COUNCIL ASSESSMENT REPORT

| Panel Reference | PPSSSH – 153 |
| DA Number | DA-1196/2023 |
| Street Address | 167 Hume Highway, Greenacre (Lot 402 of DP631754) |

Indicative Structure Plan (CBDP 2023)

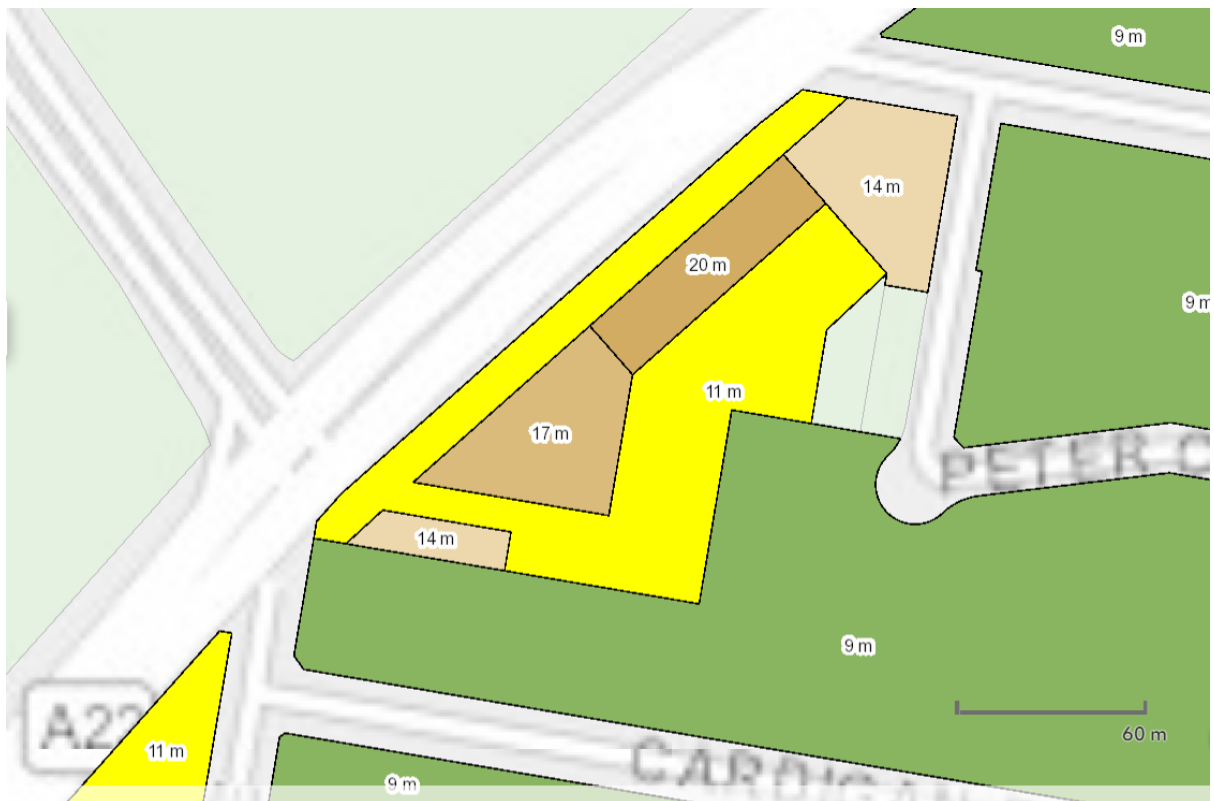
- v. The proposal does not locate buildings and site landmarks in accordance with the indicative structure plan and key design principles. The indicative structure plan (shown in Figure 4) details a four building development with more centralised, larger, single area of communal open space and a clearer site through-way from the Hume Highway to Peter Reserve. The proposal is inconsistent with the desired vision of the site as mentioned, and therefore fails to comply with C1.
